B. ADDENDUM NO. 3

C. RFP #11-029

Date: November 14, 2011  
To: All Interested Parties  
From: Steve Gibson  
GRP Division Buyer

**SAN JACINTO RIVER  
AUTHORITY  
ADMINISTRATION BUILDING**

GRP BUILDING #1  
CIVIL  
TEMPORARY DETENTION SWALE

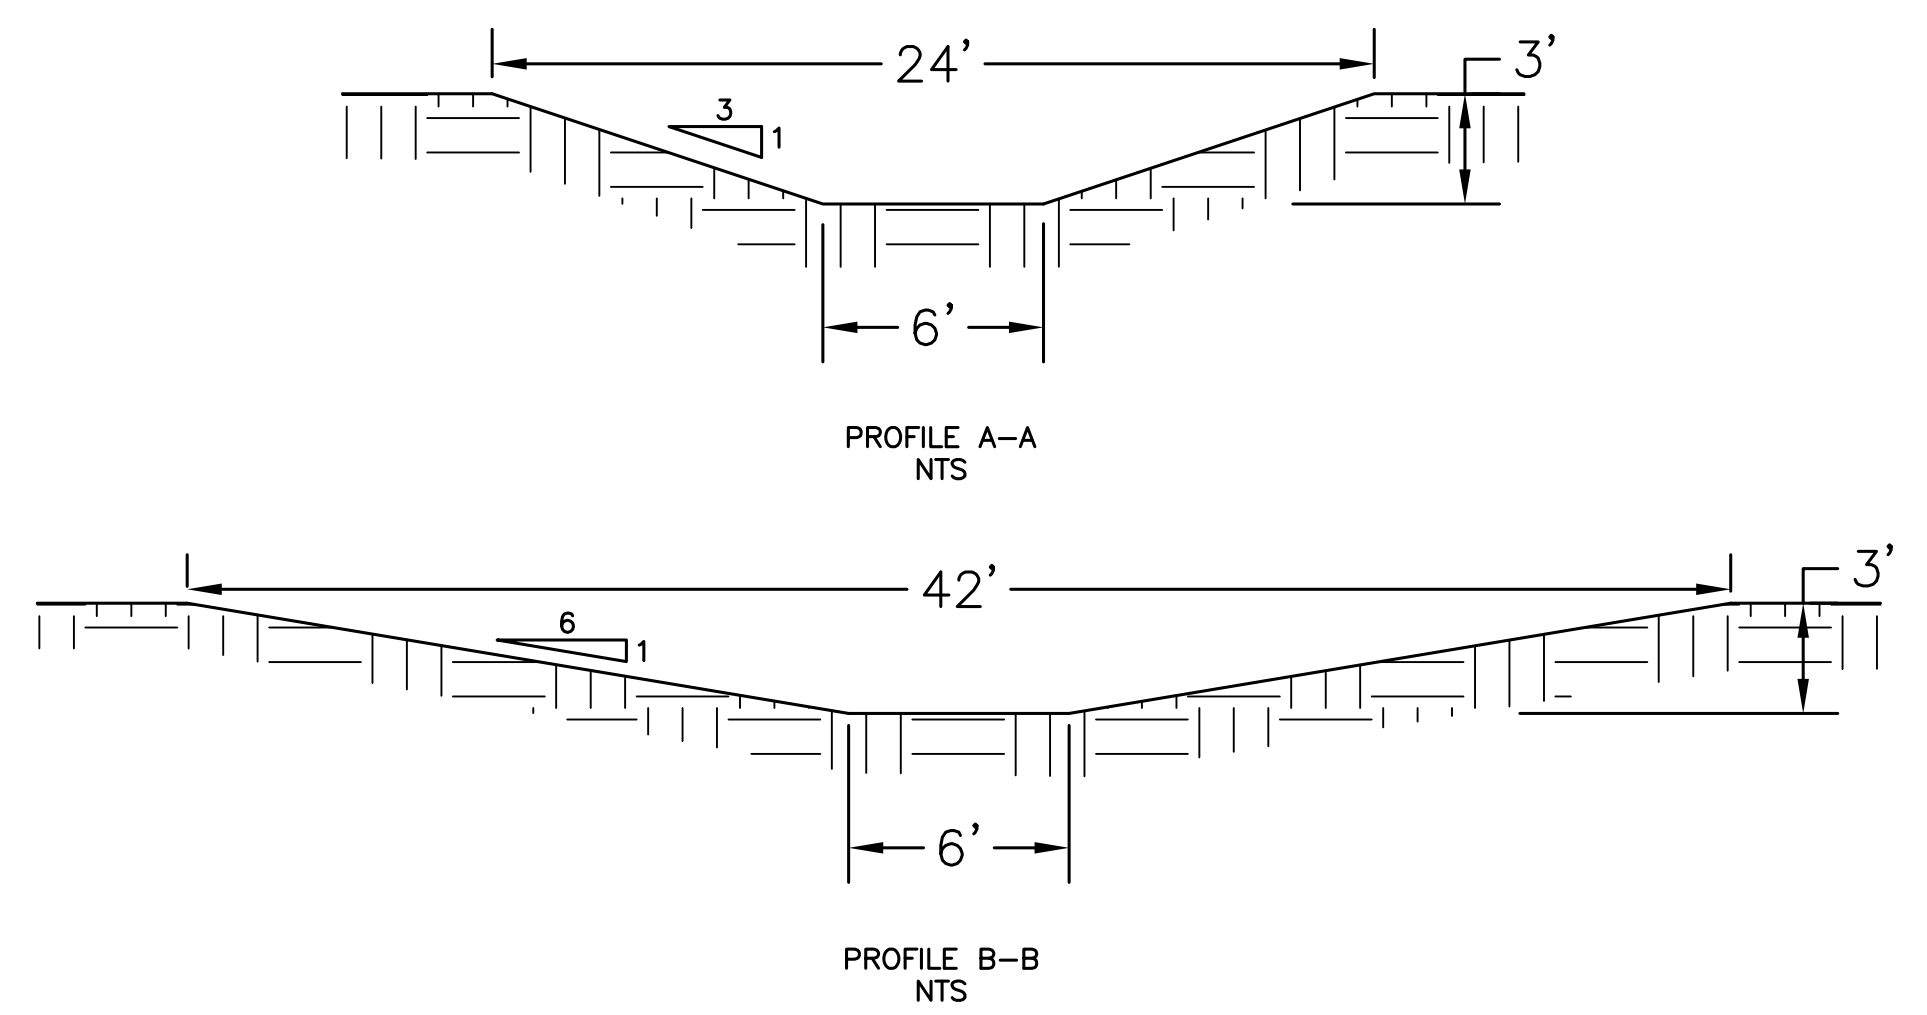
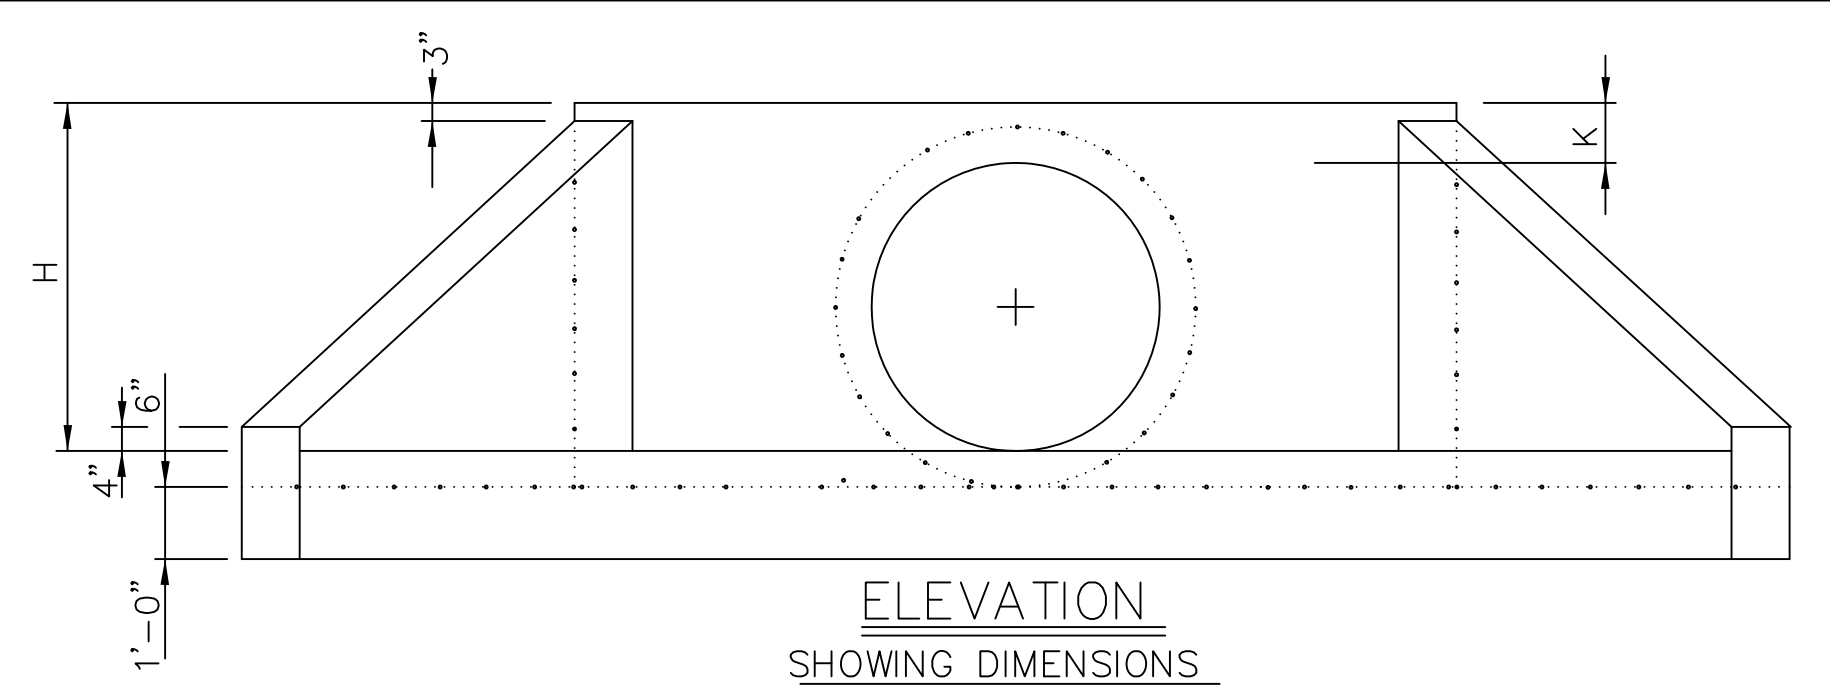
1. The revised sheet (01C-113) includes (1) the reference to the details for headwall and riprap in the callout revisions and (2) the horizontal control for the proposed detention swale. The new sheet (01C-114) contains the construction details for the proposed concrete headwall with flared wings and for the riprap where the proposed detention swale outfalls into the existing ditch.
2. Revised electrical sheets (01E-100, 01E-102 and 01E-600) issued for incorporation of 800A, 480V, 3-phase Service #2 (construction trailer power). This includes duct bank modifications as well as a pad mounted service transformer in lieu of the pole mounted transformer bank. This item No.2 only will be considered as an ADD ALTERNATE.
